CITY PLAN COMMISSION**THURSDAY, November 20, 2025****FILE NUMBER:** PLAT-25-000130**SENIOR PLANNER:** Hema Sharma**LOCATION:** Kirby Street, southeast of Capitol Avenue**DATE FILED:** October 23, 2025**ZONING:** MF-2(A)**CITY COUNCIL DISTRICT:** 2**SIZE OF REQUEST:** 0.1901 -acres**APPLICANT/OWNER:** 214 Kirby Holdings LLC

REQUEST: An application to replat a 0.1901-acre (8,280-square foot) tract of land containing portion of Lots 2 and 3 in City Block E/2011 to create one lot on property located on Kirby Street, southeast of Capitol Avenue.

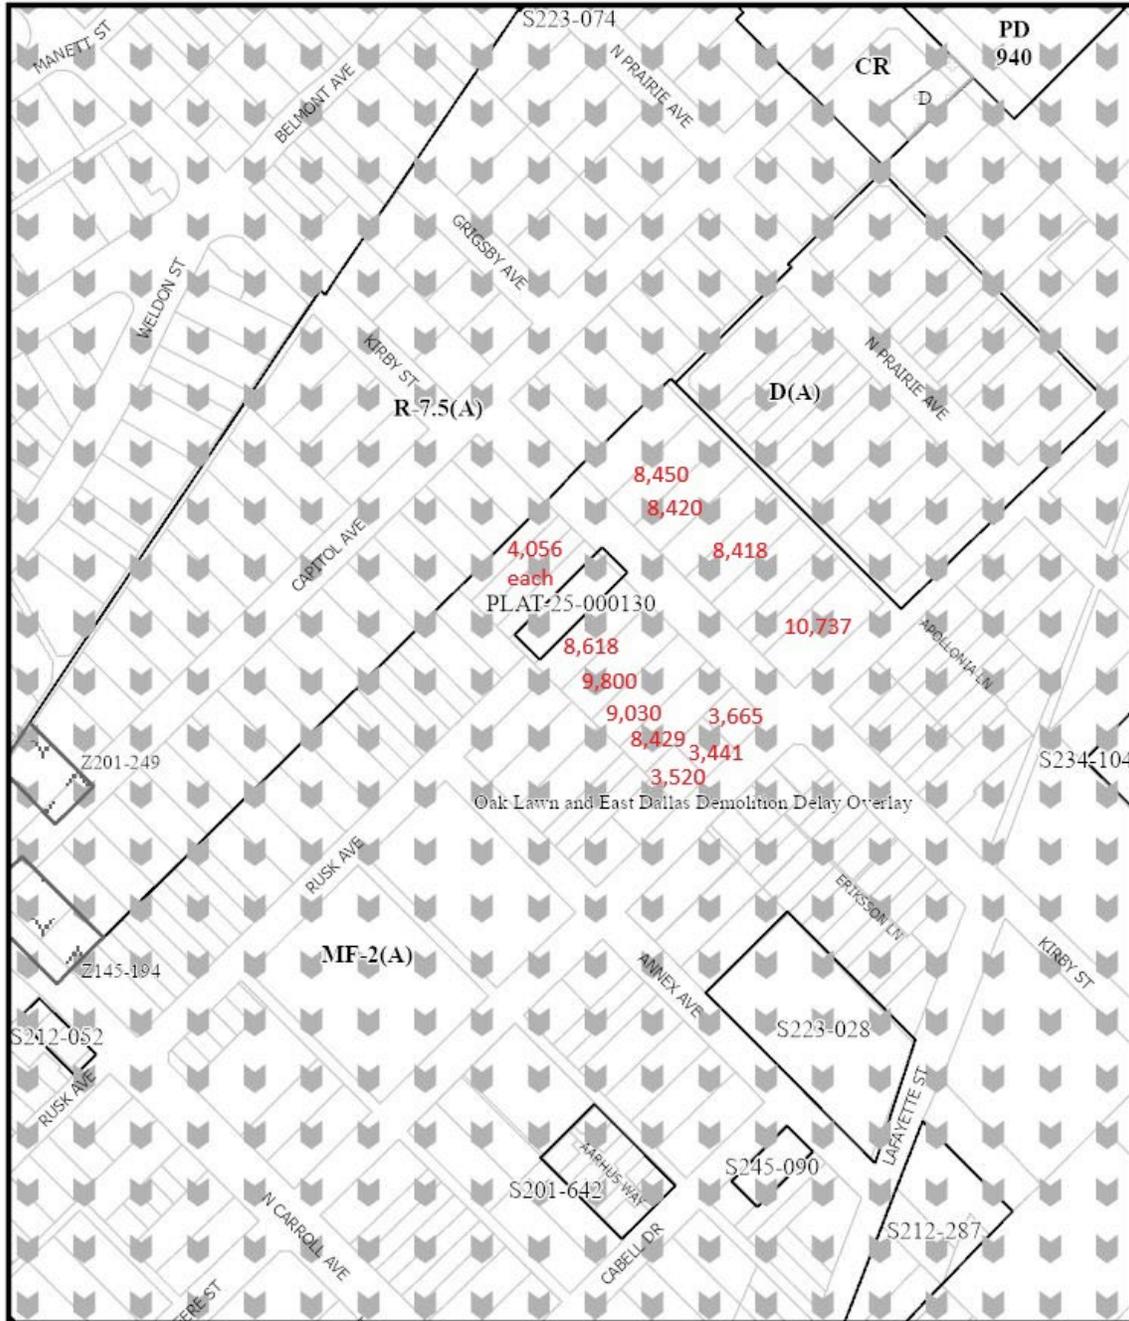
14. On the final plat, dedicate 28 feet of right-of-way (via fee simple or street easement) from the established centerline of Kirby Street. *Sections 51A-8.602(c), 51A-8.604(c) and 51A-8.611(c).*

15. Prior to final plat, submit a completed final plat checklist and all supporting documents.
16. On the final plat, chose a new or different plat name.

17. Additional design information is required for assessment. Site plan must be submitted showing proposed development, building finished floor elevation, development, existing mains – including downstream manhole, and proposed water and wastewater service locations. Submit water/wastewater engineering plans to 320 E. Jefferson Blvd., Room 200, Attention: Water and Wastewater Engineering.

18. On the final plat, change "Kirby Street" to "Kirby Street (AKA Kirby Avenue)". Section 51A-8.403(a)(1)(A)(xii).
19. On the final plat, change "Rusk Avenue" to "Rusk Avenue (AKA Rusk Street FKA State Street FKA Leroy Street FKA Capitol Street)" Section 51A-8.403(a)(1)(A)(xii).
20. On the final plat, identify the property as Lot 2A in City Block E/2011.
